Hurricane Planning Commission Meeting Agenda

February 9, 2023

Agenda Date:	02/09/2023
Application Number:	2023-ZC-02 2022-PSP-03
Type of Application:	Zone Change and Preliminary Site Plan Approval
Action Type:	Legislative
Applicant:	Todd Smith
Agent:	Mike Wagstaff
Request:	A Zone Change and Preliminary Site Plan approval from R1-10 to R1-8 PDO
Location:	Near the intersection of Gould's Wash Road and SR-59
Zoning:	R1-10
General Plan Map:	Planned Community

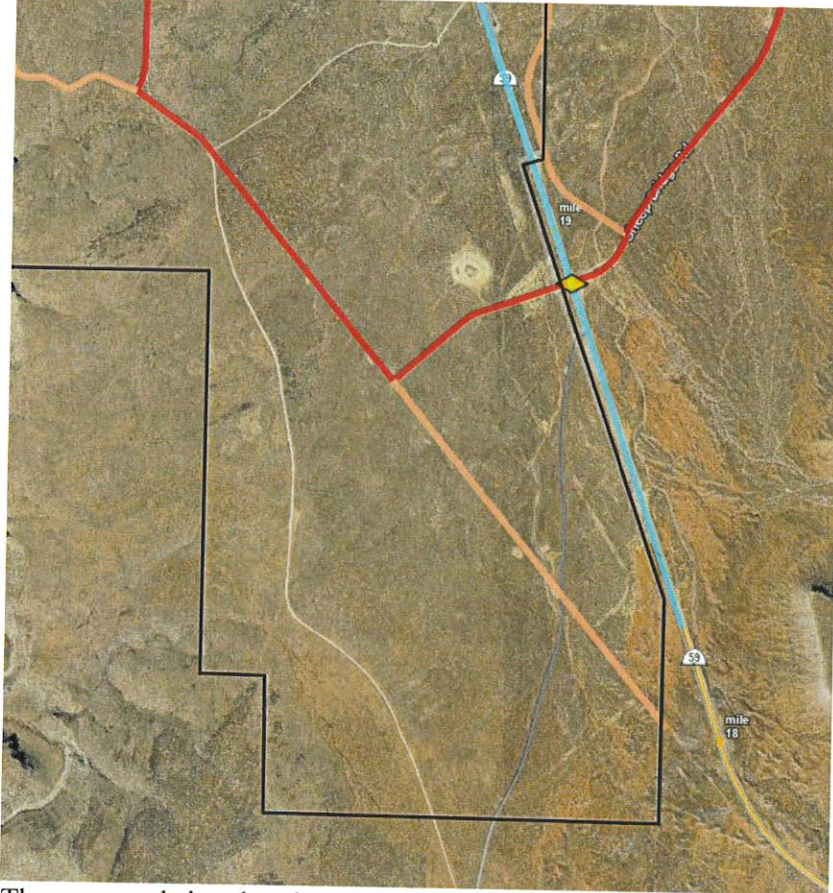
Sewer: A treatment plant is not an option. Project must connect to the sewer. Significant off-site sewer is needed for this project. Off-site sewer will require acquisition of land outside the UDOT right-of-way. off-site sewer will need to get off the hill to connect to the existing sewer. An up-size of the existing sewer will likely be required. A map is attached with a proposed sewer route to this property.

Fire: Unable to do a review without a water model. Hydrants must meet standards of 2018 IFC. Access needs more clarity.

Engineering: Right of way acquisition for utility alignments could be difficult, approximately eight private property owners and a highway crossing. Preliminary drainage analysis needed to determine storm drain needs. The existing storm drain master plan is insufficient for this area. It appears three semi-major drainage courses cross through the proposed development. Interchange planned at Sheep's Bridge Road. Proposed accesses along SR-59 are too numerous. Access management must be coordinated with UDOT. Reroute of Gould's Wash Road. Traffic impact study needed-could have major impacts on 100 S and Main St. Master planned major collector and minor collector along existing power line. Poor connectivity across city boundary to BLM property

Site Plan

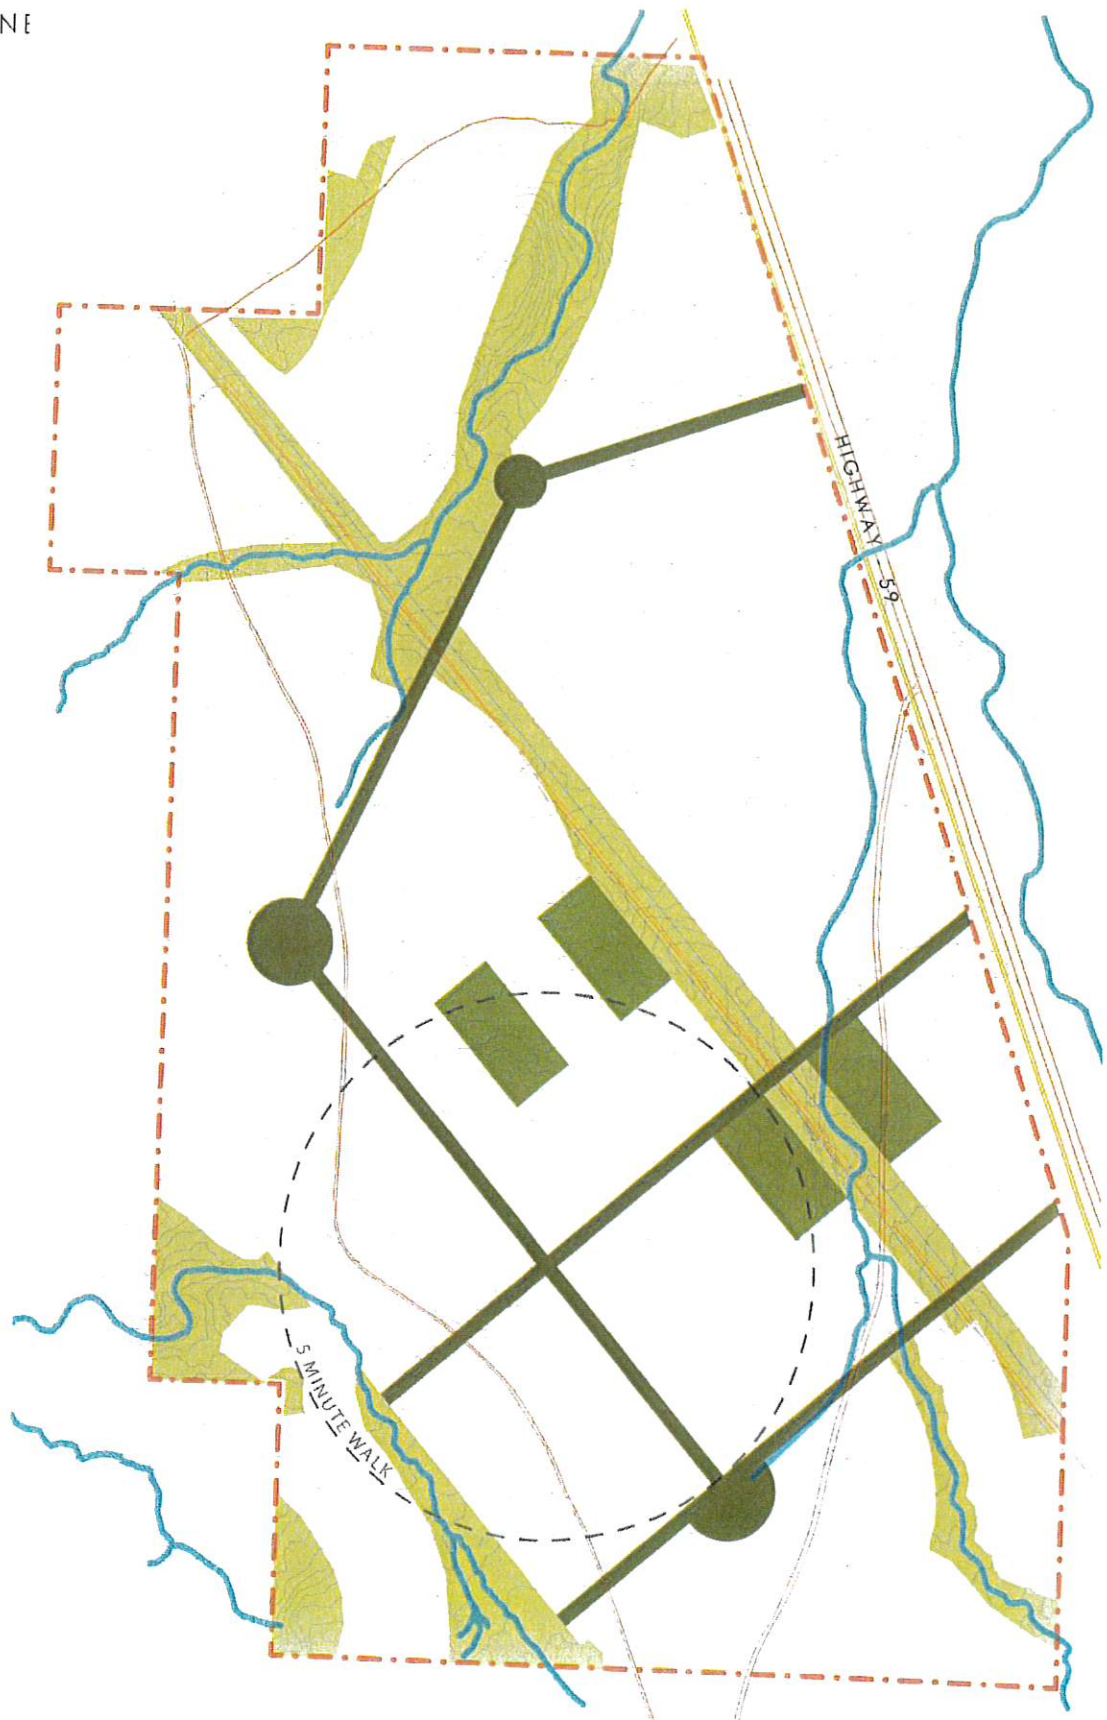
1. **Density:** The applicant is requesting an R1-8 PDO. R1-8 PDO zoning allows for up to 4.4 units per acre. The applicant is proposing *approximately* 3,083 units on 685 acres which is a density of 4.5 units per acre. The maximum number of units this development could have with the proposed zoning is 3,014 units.
2. **Transportation Master Plan:** The 2019 Transportation Master Plan depicts this area in the picture below

The proposed site plan does not appear to meet the Transportation Master Plan for this area in the following ways

- a. The applicant does not appear to account for the proposed interchange at Sheep's Bridge Road and SR-59.
 - b. The site plan does not appear to depict Sheep's Bridge Road connecting through the property to the road along the existing Rocky Mountain power line. Sheep's Bridge Road is proposed to be paved and turned into a major thoroughfare between SR-59 and Virgin.
 - c. The applicant is proposing open space and trails along the existing Rocky Mountain power line instead of the planned master planned roadway
3. The applicant is proposing cross-sections for their boulevards and some internal streets within their development. Per HCC 10-23-6 the applicant can propose and the City can approve

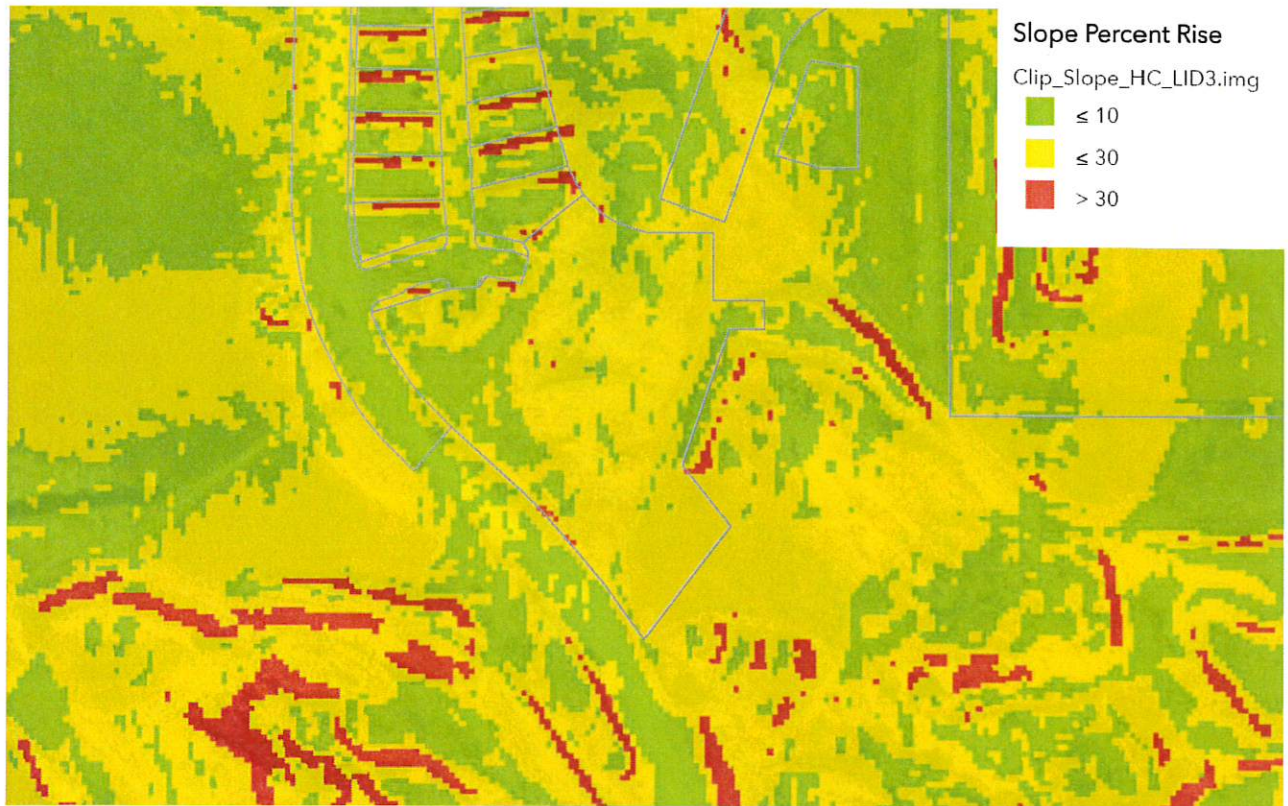
1. **Number of Lots:** The proposed subdivision has 19 proposed lots. In the master plan this area has 15 lots. The extra lots are located on the north end of the phase, 201-204. Typically, additional lots in one phase would be allowed knowing that lots will be removed from a latter phase to not exceed the overall density. Because this project is under a couple of owners, staff would like to know more information from the applicant about the plan with the shifted density for this phase.

As shown in the pictures above, the open space layout has changed. The applicant has indicated that the site reorganization of the open space has not removed any of the overall open space. According to the table listed within their application, they show that the amount of open space is

remaining the same, just moved to different locations. Staff's main concern is about the very northern lots, 201-204. These lots are positioned where the planned golf green is to be located. It is likely in the future that the current development agreement will be renegotiated and the open space repurposed within the Colina Tinta PDO. However, that has not occurred at this point and the current layout does conflict with the master plan.
